Town of Hilton Head Island Regular Design Review Board Meeting

Tuesday, September 22, 2015

**Town of Hilton Head Island
Design Review Board
Minutes of the Tuesday, September 8, 2015 Meeting
1:15p.m. – Benjamin M. Racusin Council Chambers**

DESIGN TEAM/DRB COMMENT SHEET

Sheet No. **A2.2**
Scale: AS NOTED

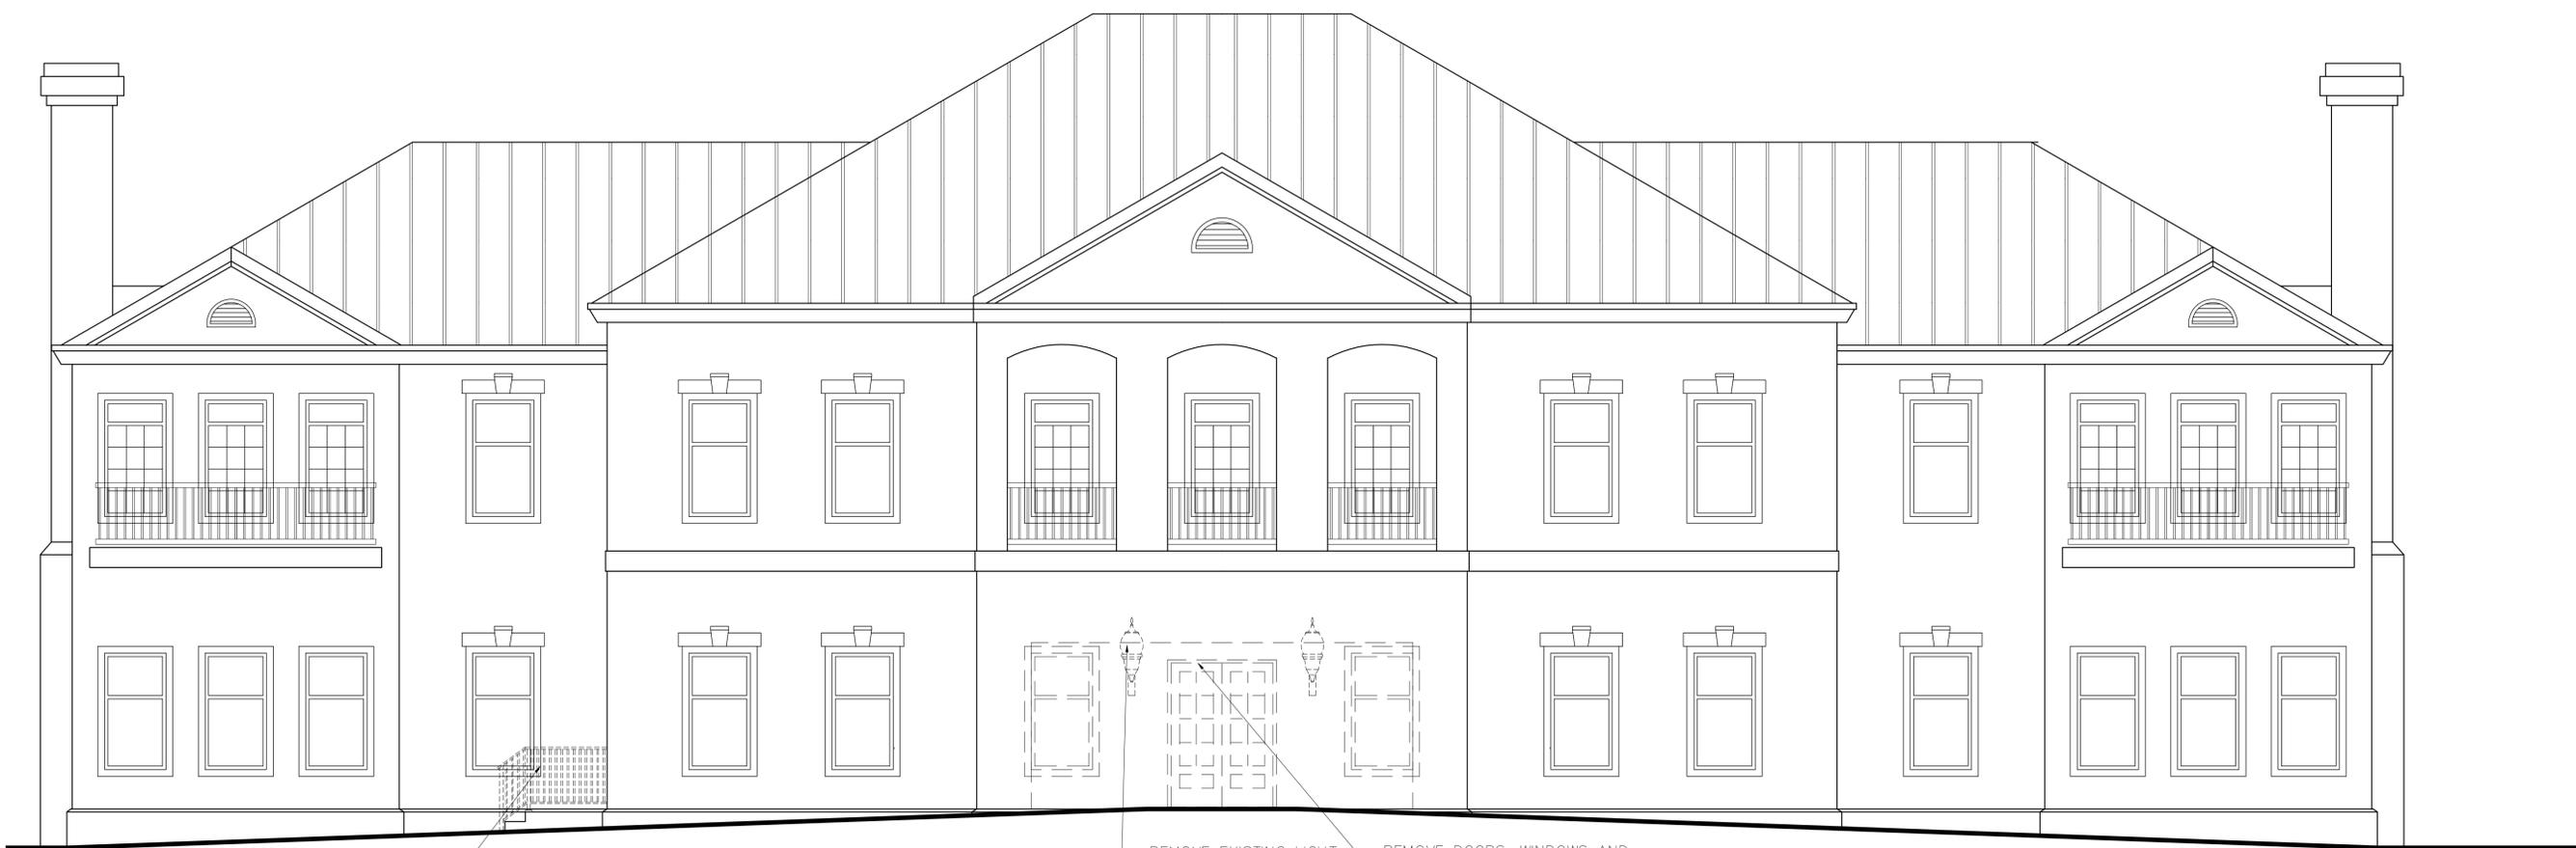
- Front door should be white versus black to be consistent with collection of adjacent buildings. **As per direction at the initial meeting, we are proposing to keep the black door.**
- Aluminum storefront on rear of building appears foreign based on architectural style and detailing. Consider alternate window configuration to allow more light. **We have revised the rear windows as per comments from the first meeting. Please see the attached elevations.**

C1.1

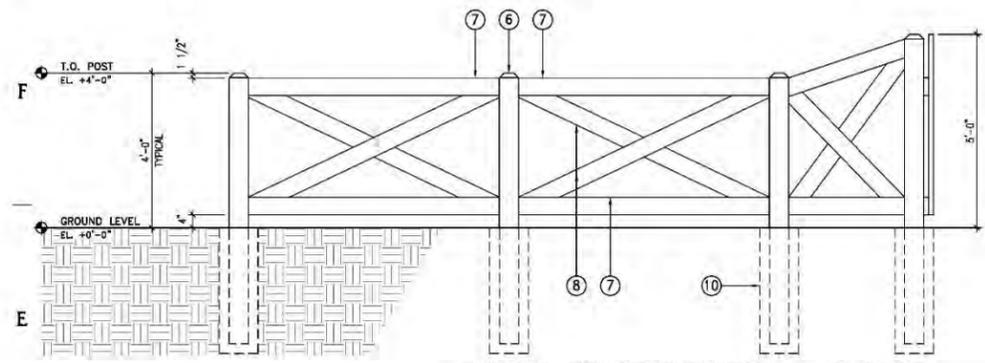
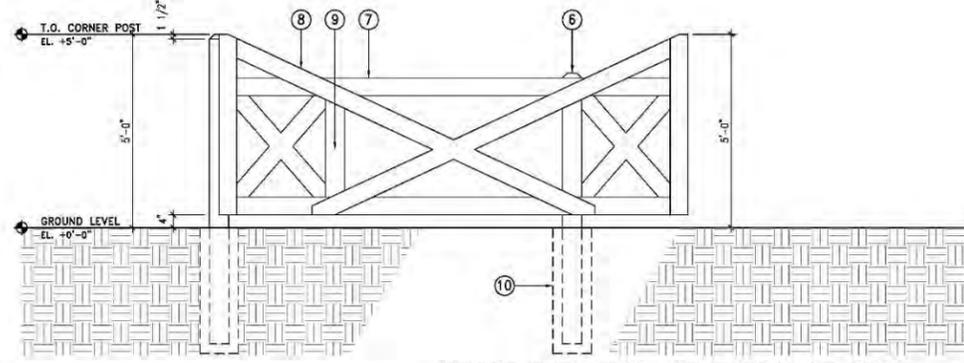
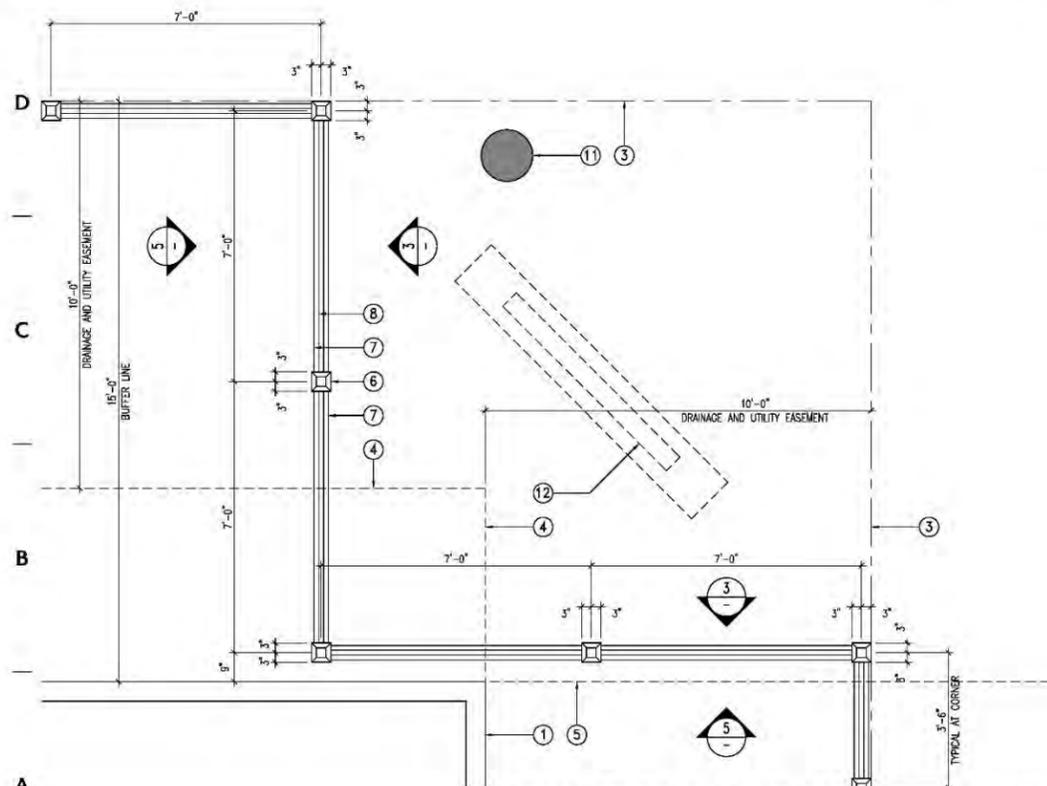
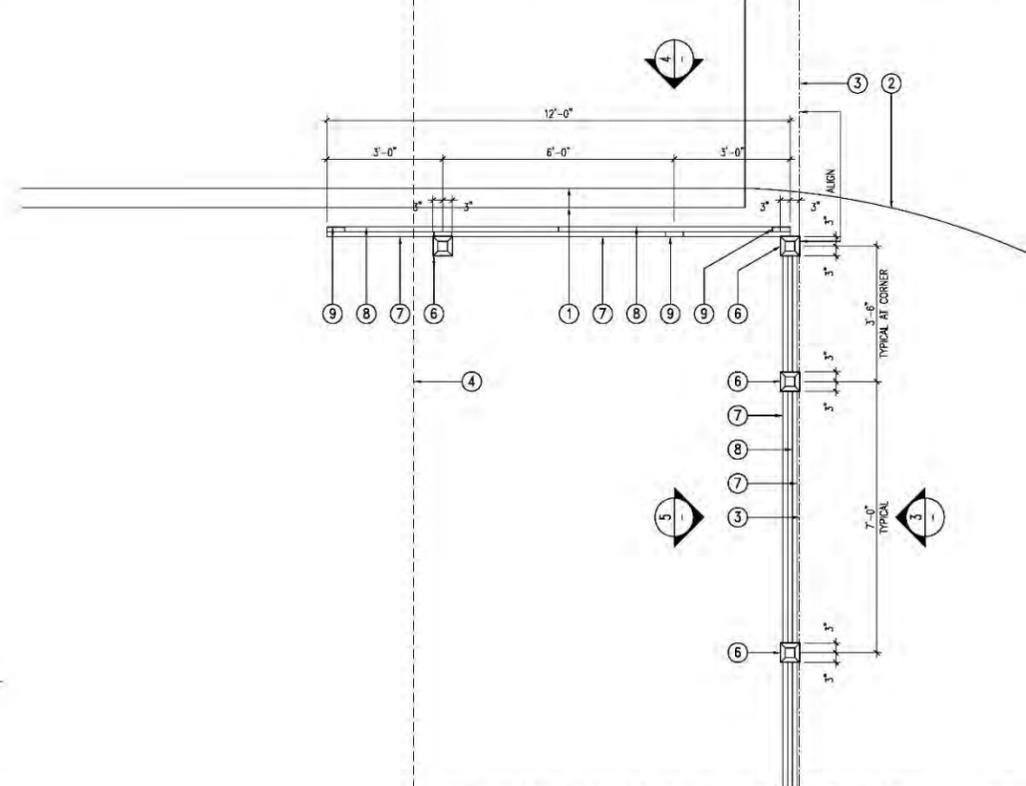
3. The perimeter property fence proposed a long Beach City Road and Finch Street has been represented correctly on all drawings with a detail sheet created for review and clarification purposes. There are no gates.
